PRODUCT CHANGE NOTIFICATION

PCN-SSR-231214

Temporary change on Thermal Pad for hockey puck SSRs

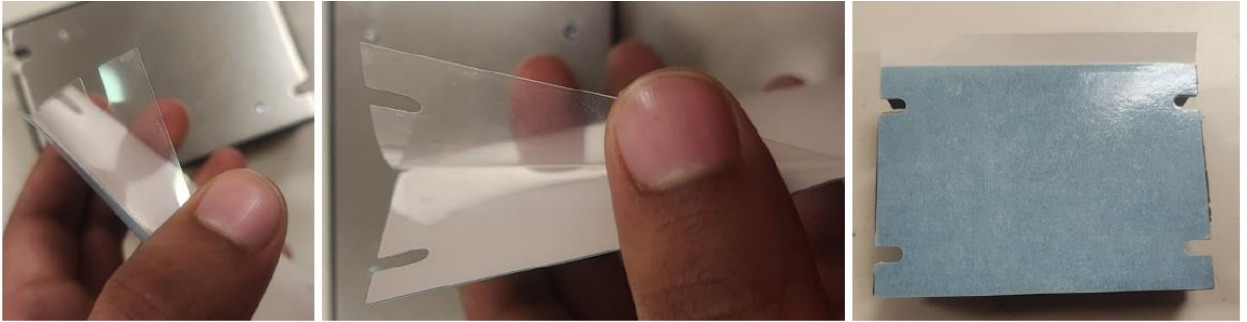
The original material used on this thermal pad is **TCF1000AL**, while the new proposed material is **JRFT-FC200**.

- a. There is a color difference between these 2 materials. The original thermal pad has a gray color while the thermal pad made with the new proposed material is pink, as shown in the images below.

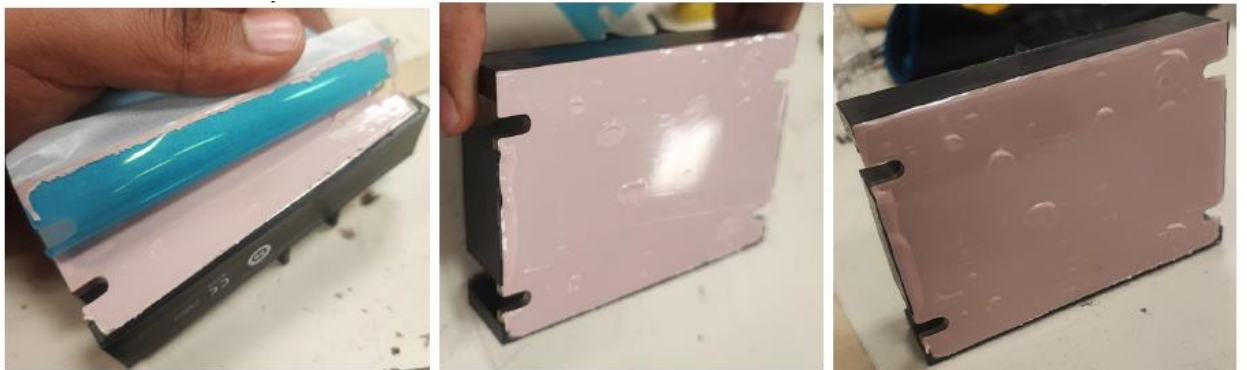
- b. The alternative thermal pad has a protective film on both sides (one clear and one blue), which needs to be removed before installation. Failure to do so will affect the thermal performance, preventing the SSR from properly transferring the dissipated heat.
- c. The original material is basically an aluminum foil sheet, while the alternative material is phase change material.

1. Have a clean surface on both the SSR backplate and the heat sink.

2. Remove the clear protective film of the thermal pad and line it up with the SSR.

3. Scrap the surface of the thermal pad with a soft tool to get out bubbles trapped inside the surface and improve adherence. Let it sit for 5 minutes before peeling off the other protective film.

4. Using the pull tab carefully remove the blue protective film to expose the thermal pad.

5. Line up the SSR mounting holes to threaded holes in the metal plate or heat sink where it will be mounted and torque it down to 20 lb-in (2.2 Nm).
